## ADDENDUM No. 1

## ITB No. 4370

# Mack Pool Interior Ceiling and Trim Painting

Due: March 31, 2015, 2:00 P.M.

G-02

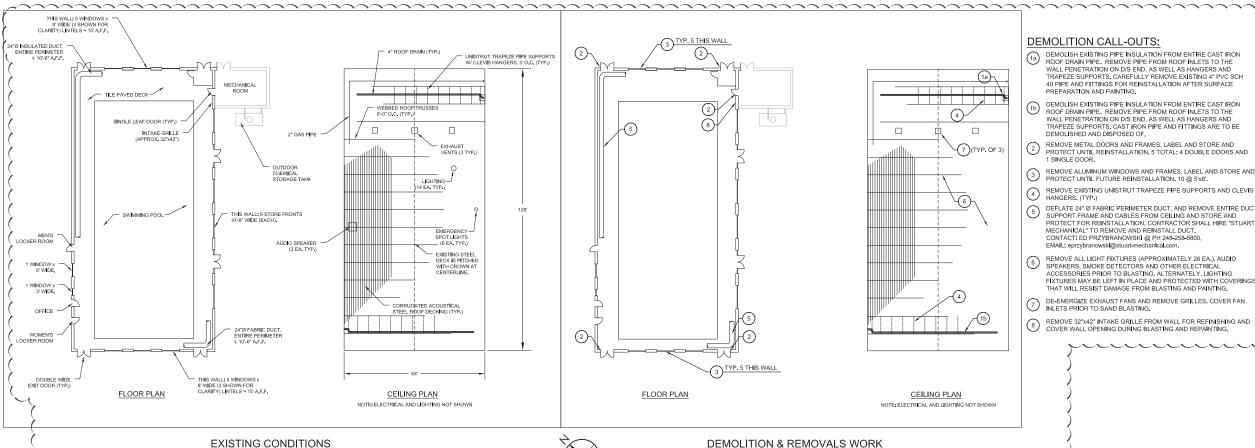
Section/Page(s)	<u>Change</u>
Specification 01370 Lead Based Paint Removal	Delete entire section (4 pages, dated: February 27, 2015).
Specification 01370 Lead Based Paint Remediation	Add entire section (6 pages, dated: March 20, 2015).
Specification 09900 Painting	Delete Schedules M1 and M2 (2 pages, dated: February 27, 2015).
Specification 09900 Painting	Add Schedules M1 and M2 (2 pages, dated: March 24, 2015).
Drawing G-02 Site Plan	Add temporary construction fence as shown.
